Vivian Sand Extraction Project

Clean Environment Commission Hearing Rebuttal

March 14, 2023

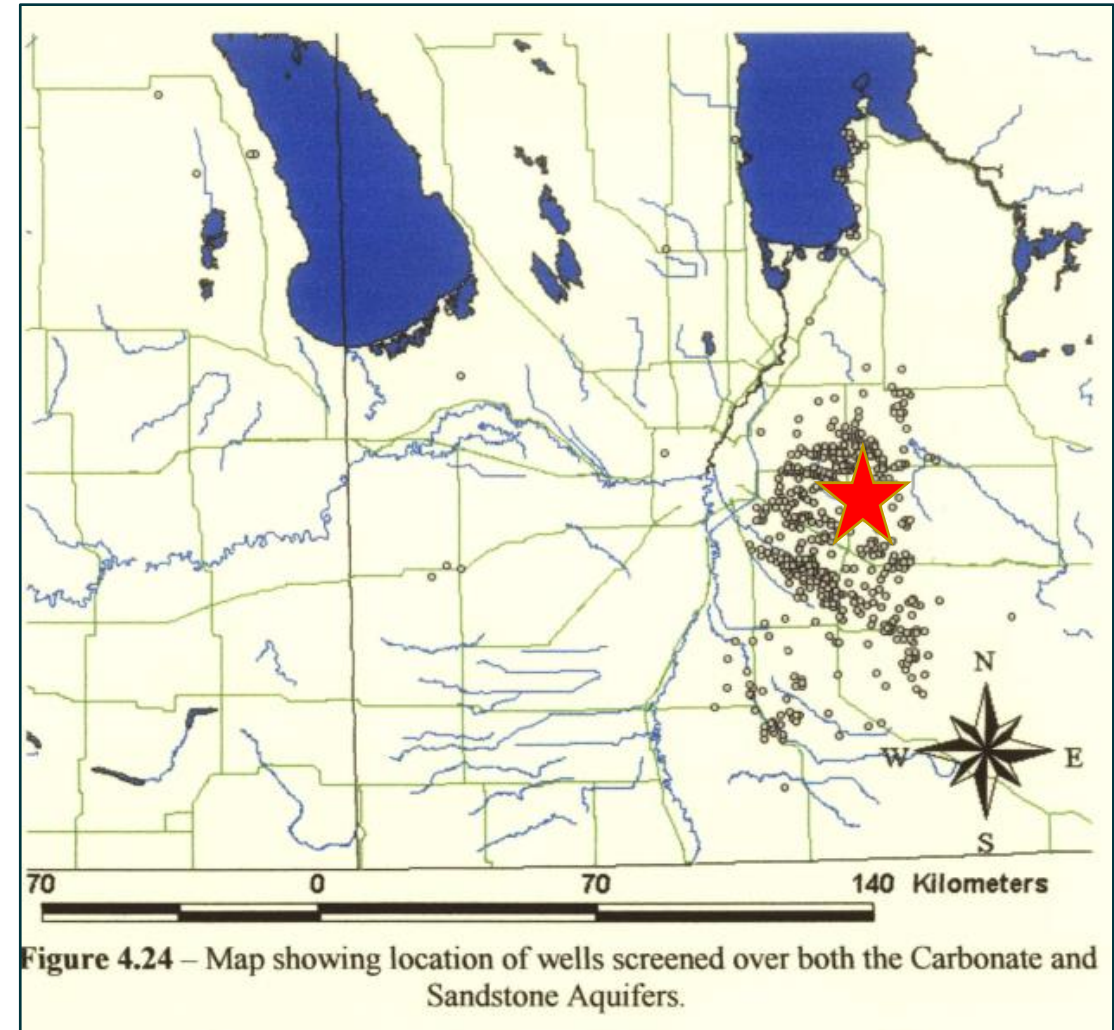
- Method of modelling shale collapse is not appropriate. (Dr. Hollander)

- This has been discussed in detail over the past two weeks.
- Water must flow through the sandstone to enter the void before it can migrate between the aquifers.
- The hydraulic conductivity of the sand was assigned to the shale within the numerical groundwater model as it will provide resistance to groundwater flow. You cannot assign an infinite hydraulic conductivity in a model.
- The hydraulic conductivity of the void is of little relevance to the overall regional groundwater flow patterns.

Joint in a Limestone Beam

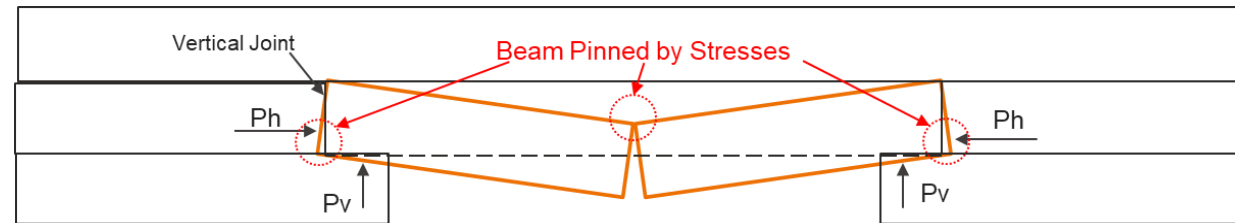
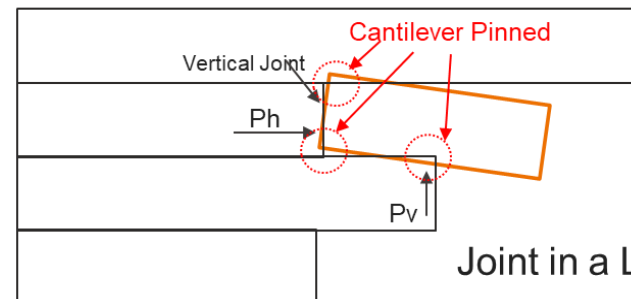
- Possible presence of vertical joints and impacts.

- If vertical joints are present, the bending failure mode remains valid. Based upon logging and other results, jointing is not common in the competent limestone.
- Vertical joints at spacings greater than the required span of beams and cantilevers (7 m and 0.7 m, respectively) are not expected to impact bending strength. Beams and cantilevers should remain in place.
- Limestone beams are held in place by confining forces on each end of the beam. See the graphics below.

Cavity Development Over Time

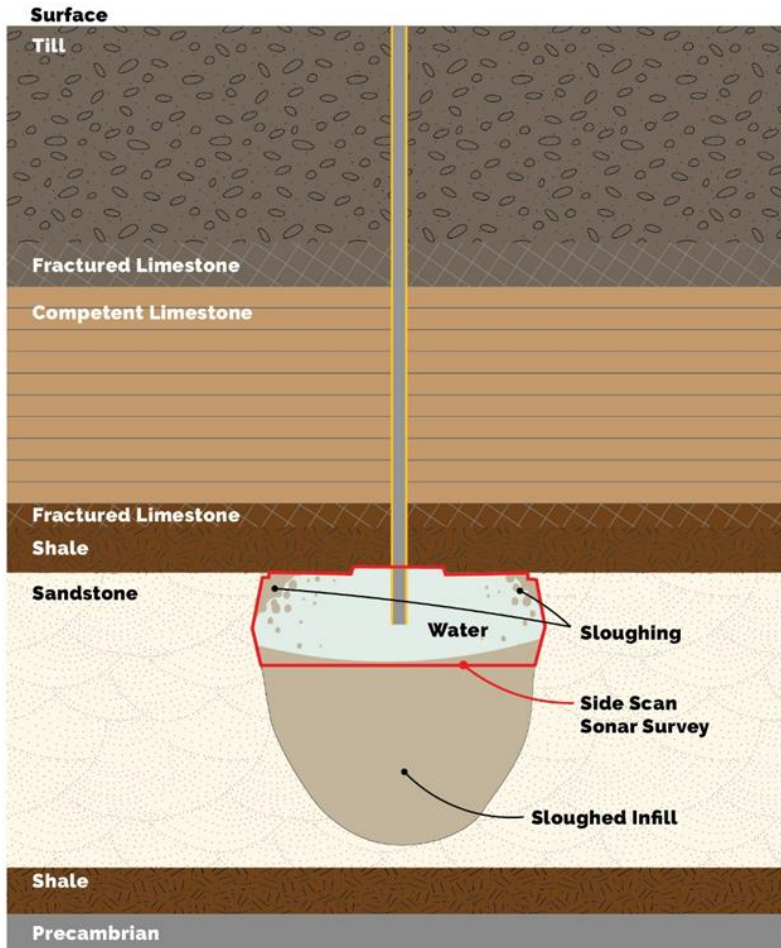
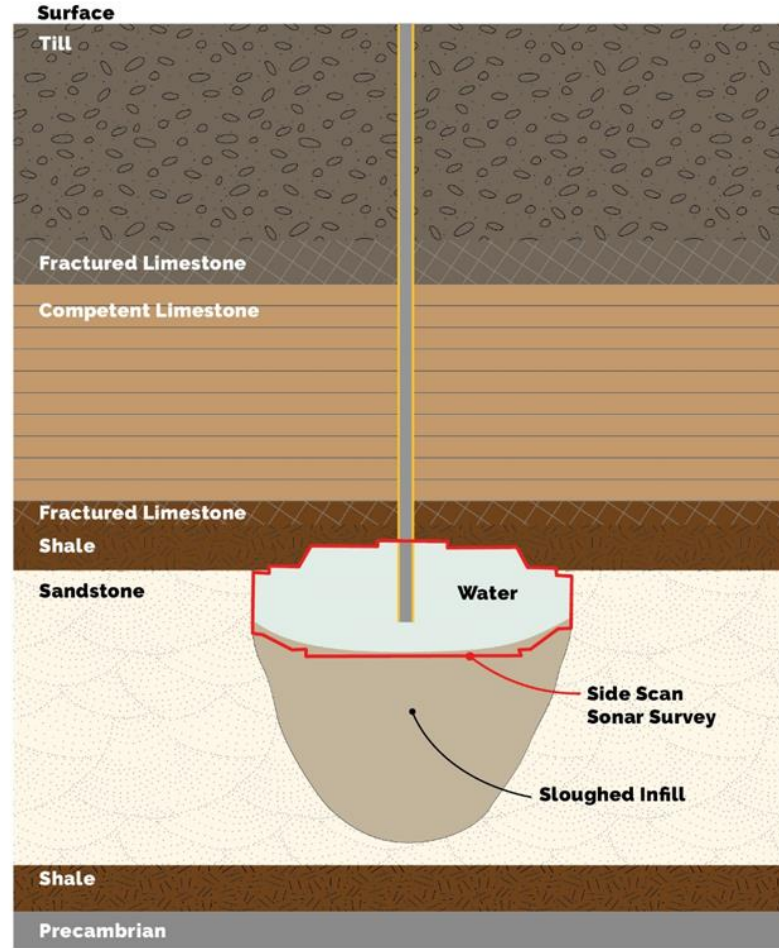
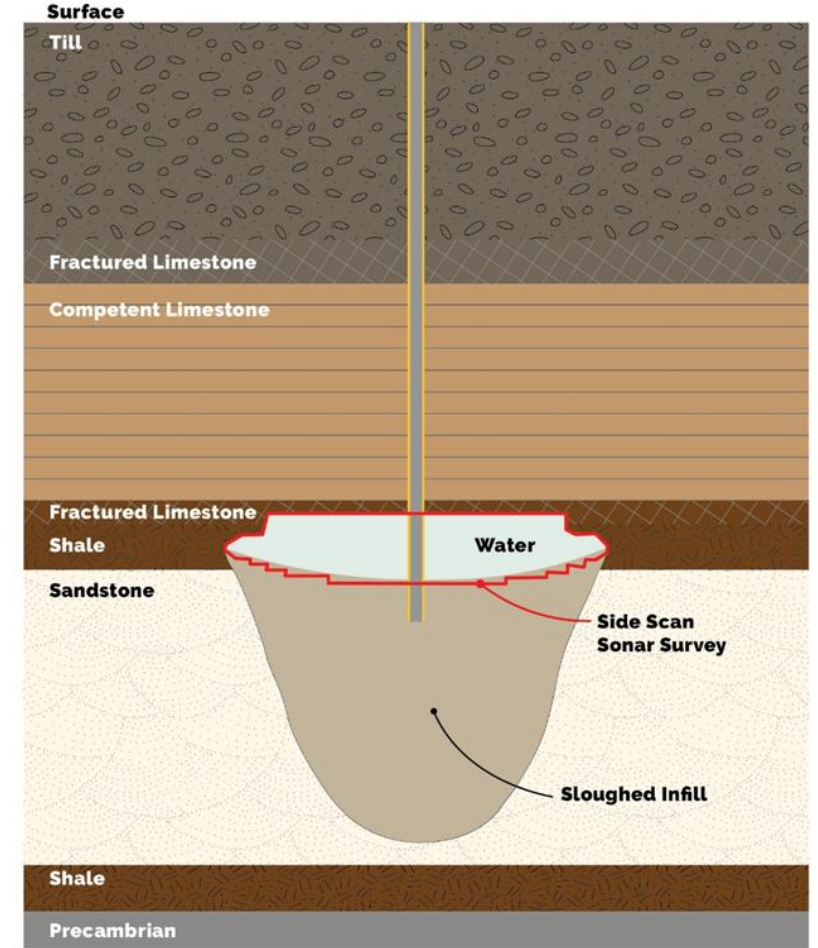
Issue or Statement: Unclear on development of cavity over time.

Figure 9. Location of Winnipeg Formation Sandstone wells and total dissolved solids from each site.

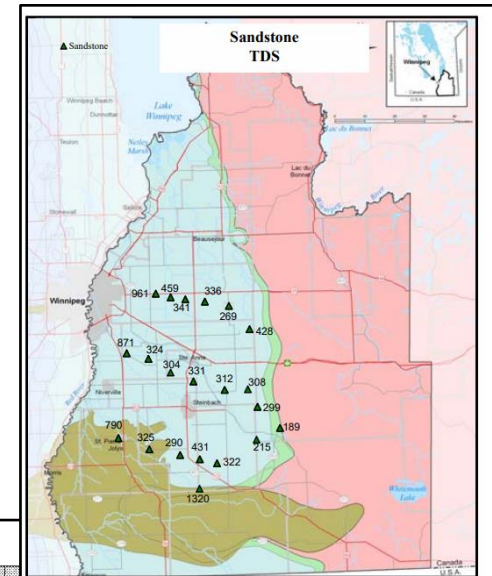
- Density-dependent modelling is required to simulate groundwater flow within the Project area. (Hollander)

- Red River Carbonate, Winnipeg Shale and Winnipeg Sandstone contain fresh water with low TDS concentrations except near the Red River.
- Effects of variability in TDS is negligible within Project area.
- Supported by conclusions of Kennedy (2002), Wang et al. (2008) and even Stafford and Hollander (2011).
- Many of the models did not include density dependent flow. Those that did concluded the effect was relatively minor as the water is fresh.

Figure 29 – Saline/fresh groundwater quality in the sandstone aquifer. – (modified source - Betcher, 1986)

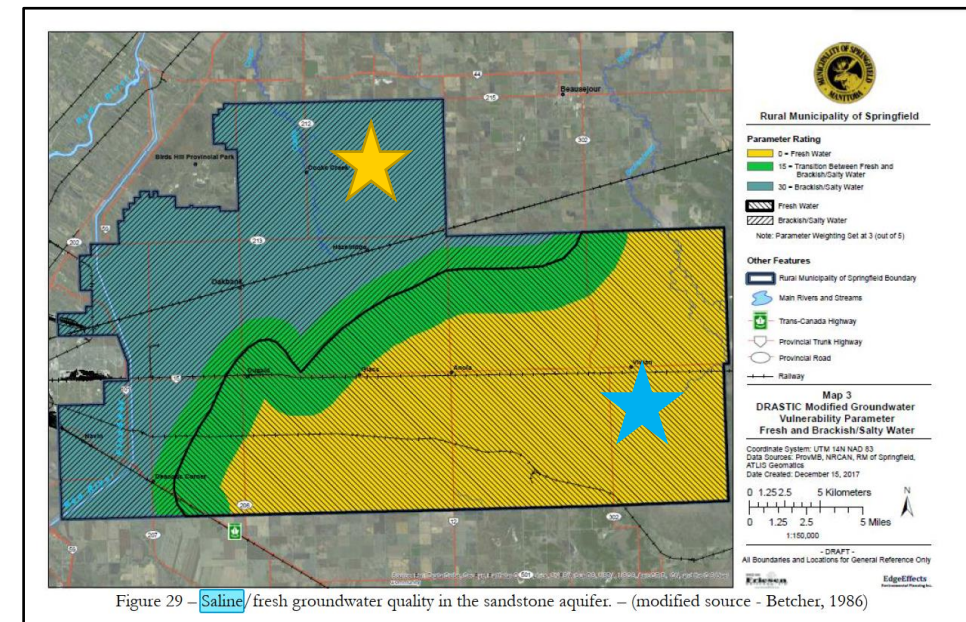
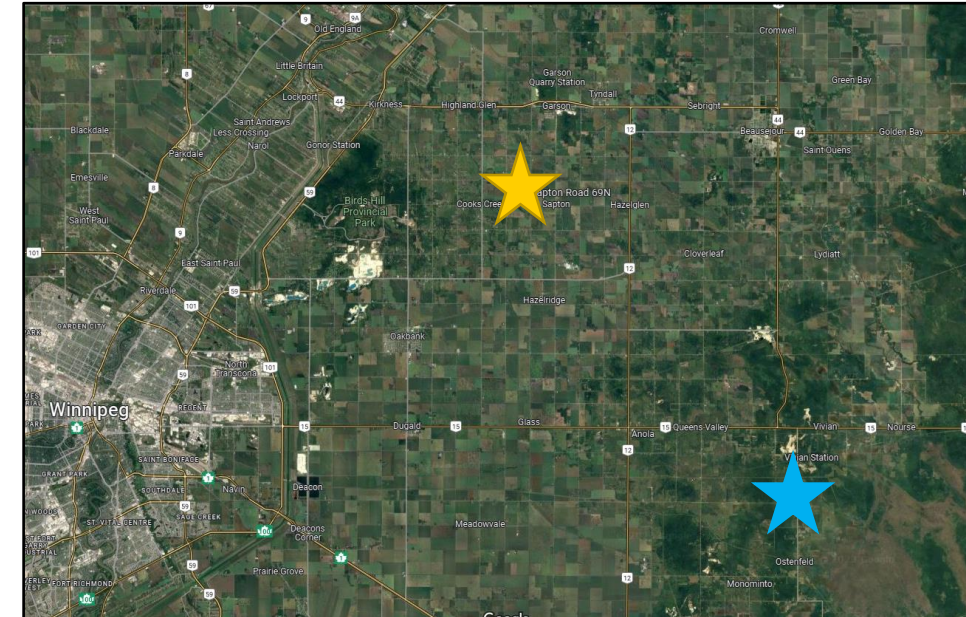
- Plumbing fixtures corroded at childhood farm (yellow star) due to presence of acid rock drainage in aquifer.
- Inferred it was related to development of area and the reaction of pyrite to the sand in the area.

- Acid rock drainage can not be initiated in the subsurface because an infinite source of oxygen and abundant sulphide minerals (pyrite) are required and are not present.
- The corrosion of plumbing fixtures in that area is likely due to the presence of saline water (not acidic water) as has been documented in the literature for decades. Salt water is also known to rust metal, which would cause orange discoloration.
- Due to slower flushing of saline water from that portion of the Winnipeg Sandstone aquifer and is totally unrelated to development or ARD.
- Project area (blue star) is a long way from the saline groundwater interface and there will be no impacts on salinity or ARD.

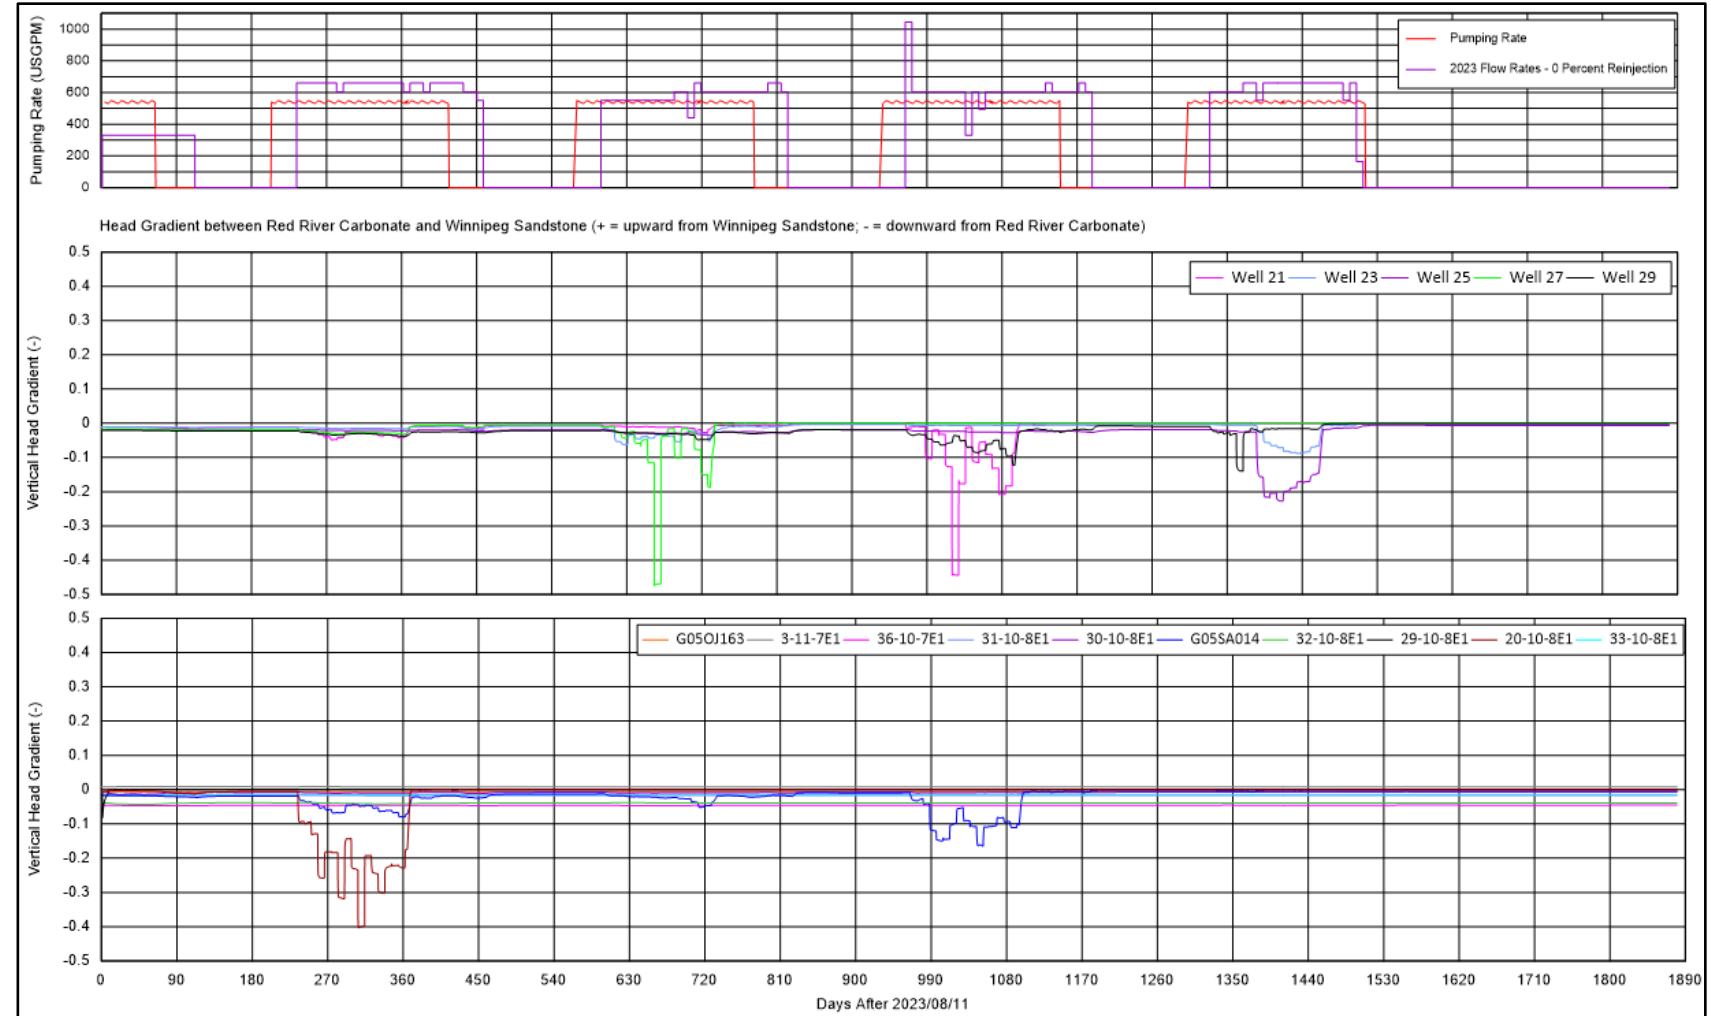
- It is critical that Red River Carbonate and Winnipeg Sandstone aquifers remain separated.

- The primary effect has been equilibration of water levels, which will reduce or eliminate vertical hydraulic gradients and limit the bulk exchange of waters between the aquifers.
- Vertical groundwater gradients are presently neutral to slightly downward and are simulated to reduce even further following operations.
- No vertical gradient, no exchange of water.
